Land North West of Southwater

LLFA Response

To: Eleanor Read - WSCC
From: Darren Brown
Cc: Aaron Wadhams/ Simon Purcell
Ref: TN-LLFA-001 ([Rev: P02](#))
Date: [2026-07-14](#)
Subject: DC/26/0366 – Land North West of Southwater

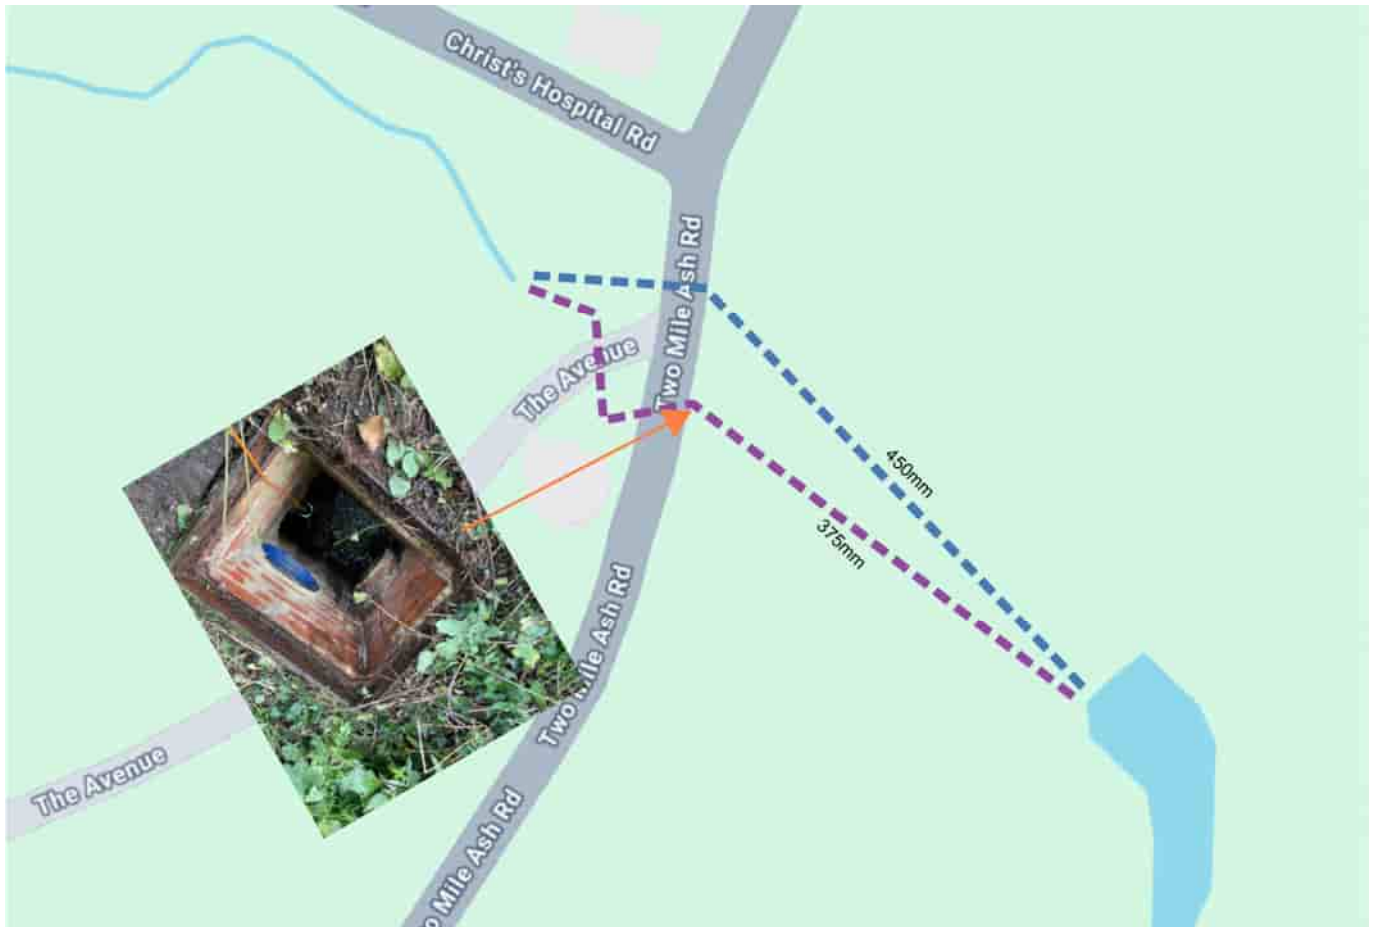
Similarly, it appears that Basin 2 is proposed to discharge into a ditch that, based on the topographical survey, does not have onward connectivity, as there is a label “ditch fades in this area”. Based on the information submitted it is assumed that the watercourse is culverted from the location of the ‘pond’, under Two Mile Ash Road, then the watercourse reopens within the grounds of Christs Hospital School. The details of this culvert (route, capacity and condition) and onwards connectivity of the watercourse are unknown currently and as such further investigation is required. This is to ensure that this watercourse is able to receive flows without increasing flood risk elsewhere. If it is found that the watercourse cannot receive these flows, alternatives will need to be explored at outline stage, to ensure there is a viable method of draining the north catchment. This is not something we can condition for reserved matters/detailed design stage, as if it is found that the watercourse does not have onward

connectivity, this is likely to require alterations to the parameter plan. For avoidance of doubt, the onward connectivity of all watercourses that it is proposed to discharge surface water at restricted rates to, must be demonstrated at outline stage.

Following the investigation connectivity of the Basin 2 outfall could not be located and is believed to have been culverted/filled historically to provide agricultural access. As such the proposed outfall has been relocated to discharge directly to the ordinary watercourse/pond, see updated strategy drawing appended to this note.

The existing pond then has two flow control weir chambers as seen in the photos below these were partially blocked at time of visit but flow was still possible to pass over the weir inlets. Following the visit it is was believed to be culverted along the red line to the north of Two Mile Ash Road where an existing headwall was located flows then continue along the existing watercourse highlighted green. The existing headwall provides outfall to the watercourse for two large culverts in the direction of the control structure located on the edge of the existing pond see photo below. Again, full connectivity could not be proven, and further clearance and CCTV surveys were commissioned to identify the connection. The CCTV was undertaken on 5th June 2026 and the identified routes of the 2 connections are shown below. Full report will be appended to this note once available.

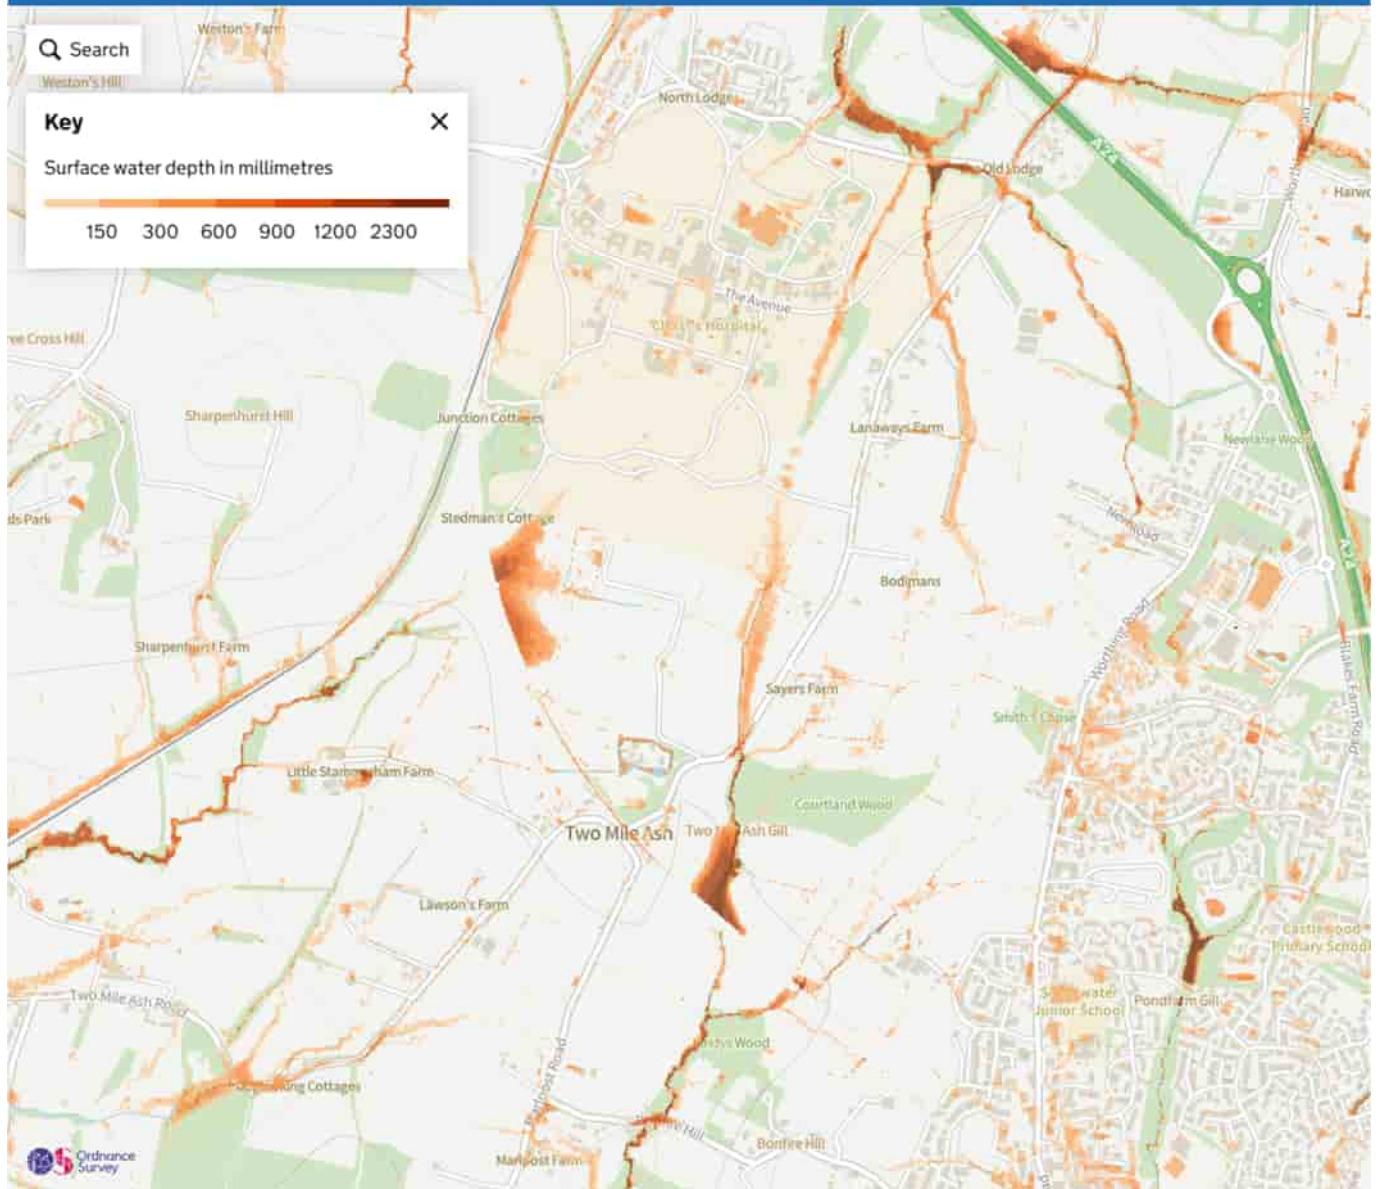
We would suggest that the Risk of Flooding for Surface Water map is not of a suitable scale for this site. We have compared it with the proposed masterplan using internal mapping, however local residents, the LPA and other relevant consultees may not be able to do this. In addition, and as stated on GOV.UK, the Flood Map for Planning mapping should be used for planning, rather than the Check Your Long Term Flood Risk Mapping.

This is partially addressed. The fluvial flood zones rather than the surface water flood risk mapping have been included in the written response. We request the surface water flood risk from Flood Map for Planning is submitted. The climate change layers will also need to be submitted. It is essential that up to date mapping is used at outline stage, to ensure there are no future conflicts at reserved matters.

Noted re above images to be replaced with those below however, no impact on flood risk.

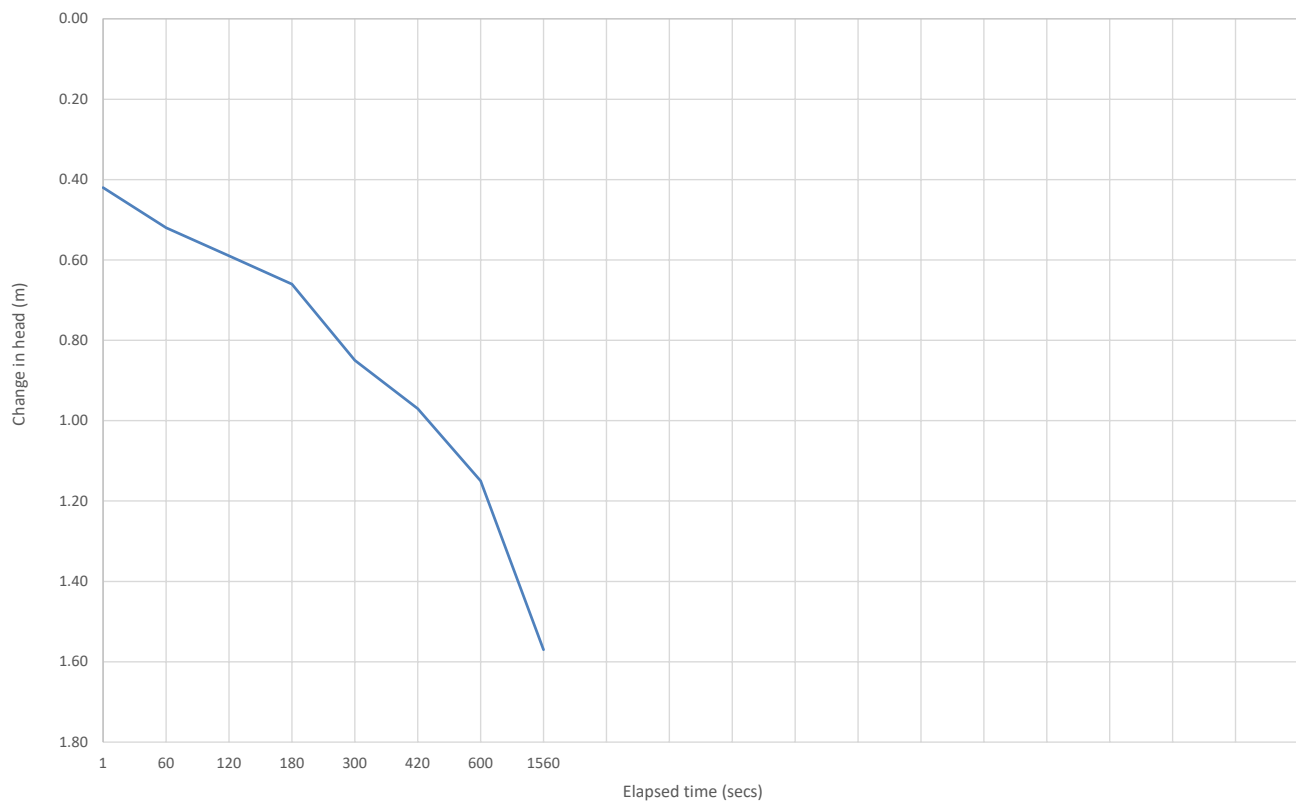
While the proforma says in Section 7 that infiltration tests have been completed, these have not been provided.

Site investigation was undertaken by GESL 5 infiltration tests were carried out across the Site, with two tests being unable to produce an infiltration rate due to the lack in fall in head. The remaining tests gave results between 2.47x10⁻⁸m/s and 8.61x10⁻⁸m/s, confirming the “slowly permeable” nature of the soils. A copy of the GESL report has been appended to this response. Further infiltration testing should be undertaken at reserved matters stage for each phase as the site progresses.
